Corpus Christi LNG Project

Docket No. CP12-507-000
Docket No. CP12-508-000
DOE Docket No. FE 12-97-LNG
FERC/EIS-0252F

Corpus Christi LNG Project
Final Environmental Impact Statement

Federal Energy Regulatory Commission
Office of Energy Projects
Washington, DC 20426

Figure 3.1-2 Terminal Site Alternatives

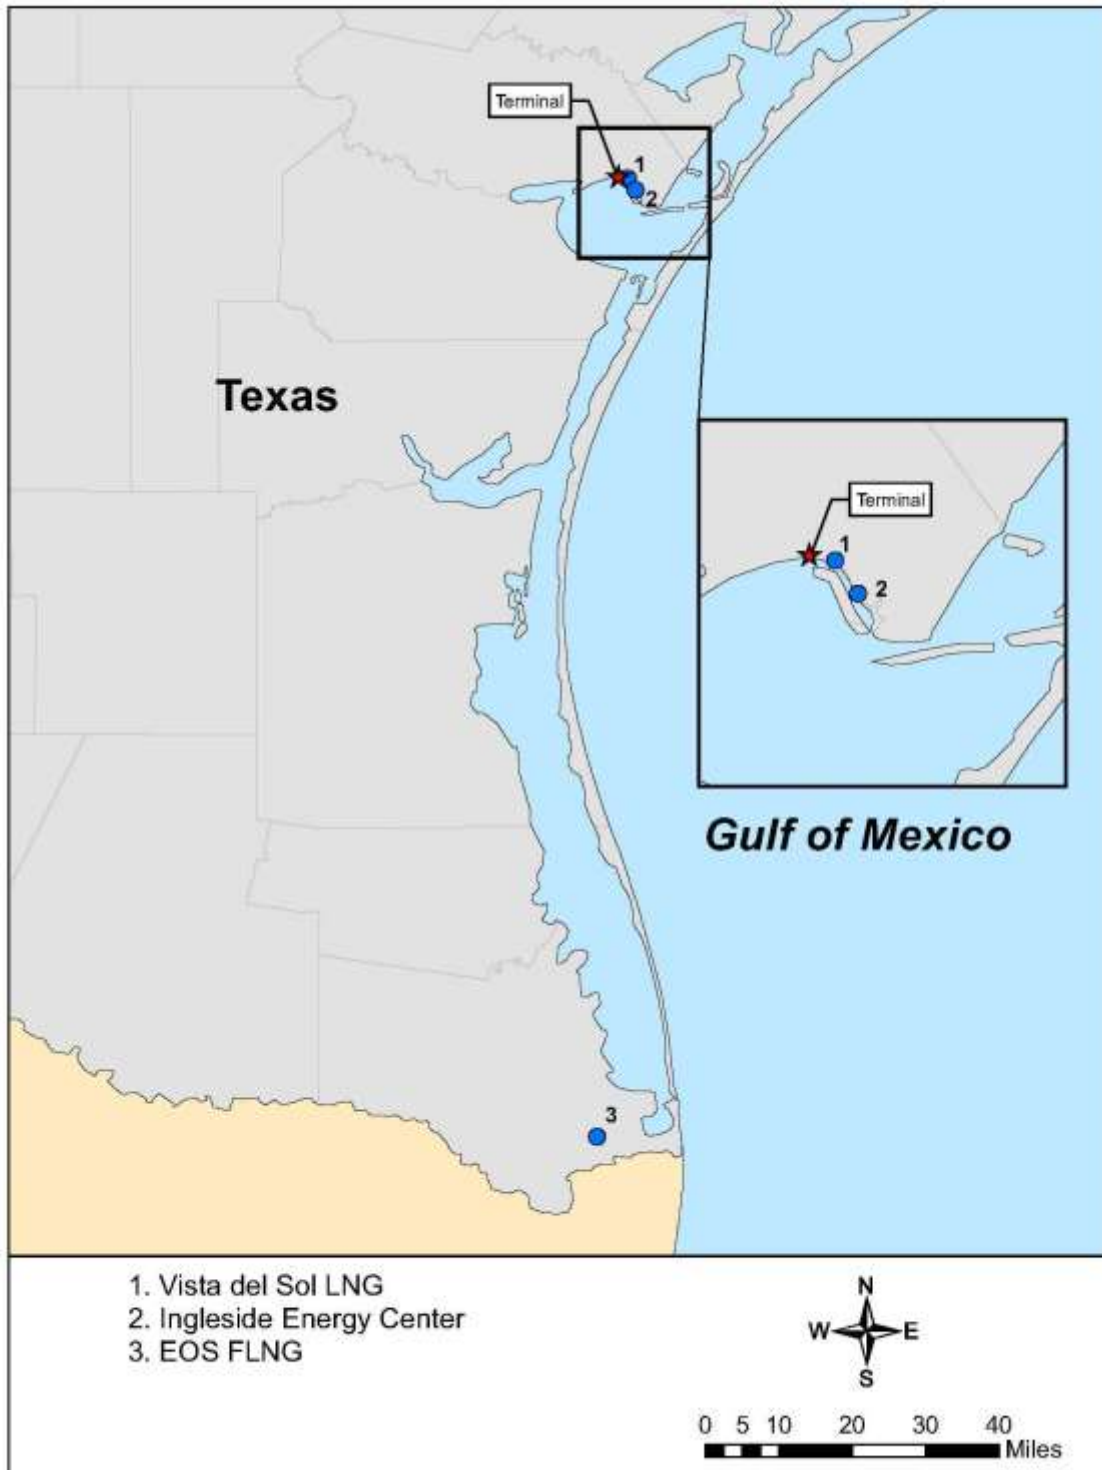
AP1-26	3.0 Alternatives 3.1.4	3-14	Terminal site alternatives Figure 3.1-2	The locations of the Terminal site and the Vista del Sol LNG site appear to be reversed.

AP1-26: Figure 3.1-2 has been revised in the final EIS to depict the correct locations of the Terminal site and the Vista del Sol LNG site.
